# Technical Service Information

## **THM 4L80-E NO REVERSE AND/OR BROKEN CASE**

Figure 1

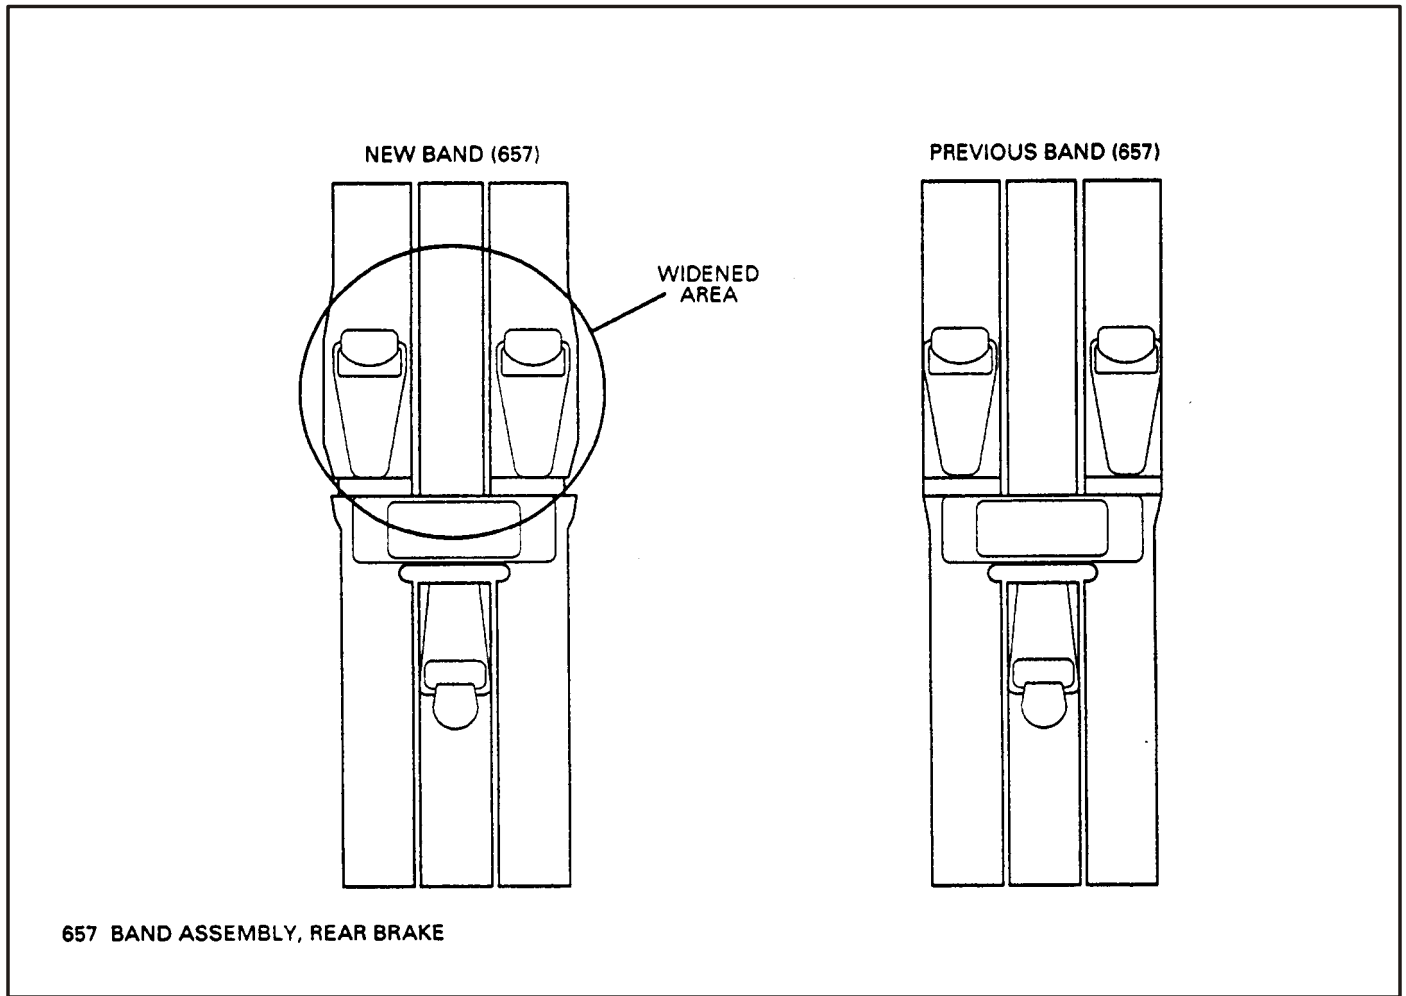
**COMPLAINT:** Some THM 4L80-E/4L80-E transmissions may experience a no reverse condition and/or a broken case assembly in the area of the rear band anchor pins.

**CAUSE:** This is caused by the lugs on the rear band assembly not holding on the case anchor pins, causing the reaction drum not to hold.

**CORRECTION:** Beginning on April 11, 1992 (Julian Date 101) all THM 4L80-E/4L80-EHD transmissions were built with a revised reverse band assembly which is wider in the band lug area (See Figure 1), and should be used during all rebuilds.

Reverse Band Assembly (New Design) ..... 8681620

Figure 2

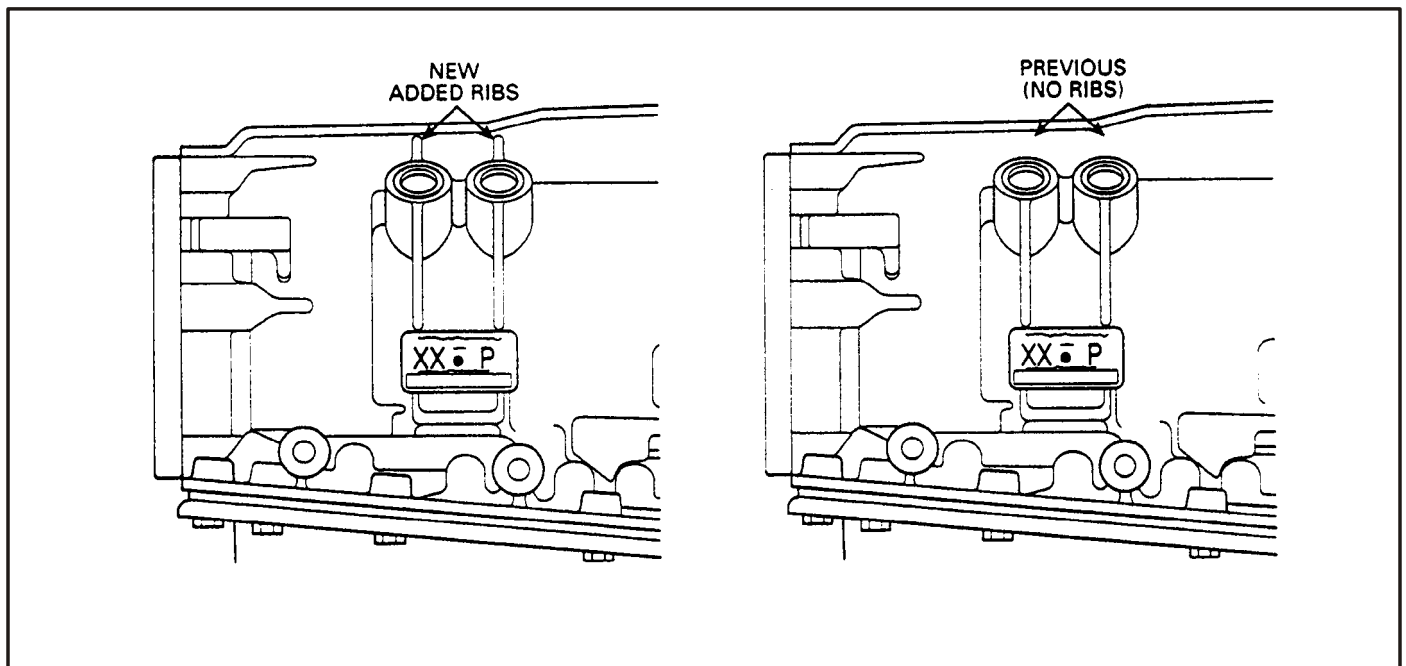
All 1992 model THM 4L80-E/4L80-EHD transmissions were built with a new case assembly with "Added Ribs" in the anchor pin area (See Figure 2).
